Wednesday, February 28, 2024
City of Sydney Council

We, [REDACTED] and [REDACTED] (respective owner and occupants) of [REDACTED] are writing to you to raise our concerns and objections relating to, **DA: D/2022/673/A, 43 Toxteth Road Glebe.**

Re: D/2022/673/A 43 Toxteth Road Glebe

Section 4.56 modification to a development consent granted by the NSW Land and Environment Court. Proposed amendments involve the reinstatement of the external wall and roof of the western rear wing, and a change in roof material for the addition.

Figure 4 The new wing of the western elevation of 41 Toxteth Road will be roofed with traditional Marseilles tiles.

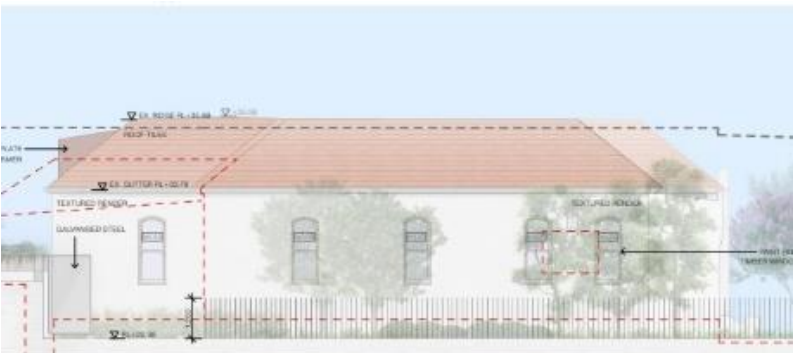
Council's deliberations on the choice of roofing material for this large addition in a heritage conservation area also need to consider the development application approved for 41 Toxteth Road (D/2022/1337) in June 2023.

Like 43 Toxteth Road this is a corner site with a long elevation facing Maxwell Road. The new wing is to be roofed with traditional Marseilles tiles (re Figure 4).

The materials used for the roof of the new wing should be informed by the materials that contribute to the character of the conservation area

Figure 6 Approved plans for the northern verandah.

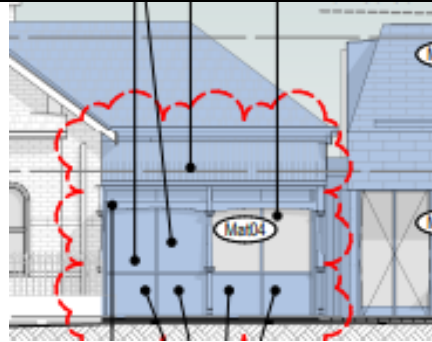
The plans approved by the Court include retaining the extant posts and frieze of the northern verandah and replicating the missing elements (see figures 5 and 6 above). Drawing DA1-3101 does not make it clear where the original fabric will be reinstated and where new fabric will replicate the missing elements.

1. The change in the approved roofing materials be rejected.
2. The applicant provide more detailed drawings of the eastern verandah showing where the original posts and frieze material will be reinstated and where they will be replicated.
3. The applicant provides more detailed drawings of the plant room be provided.

Figure 7 The recently constructed wall on Maxwell Street

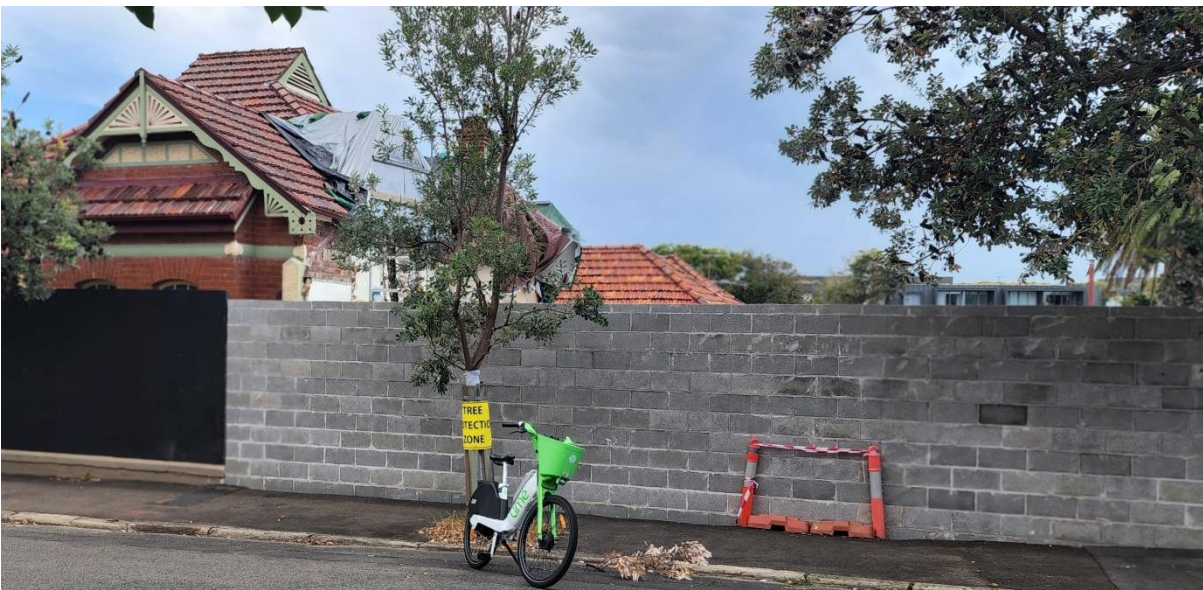
The Society would like Council to check that the height of the wall complies with what the Court approved.

We are also concerned that the break in the wall (see figure 8 below), in the Court approved scheme which denoted the end of the original house and to some degree made the wall look less forbidding appears to have been deleted and request that it be reinstated.
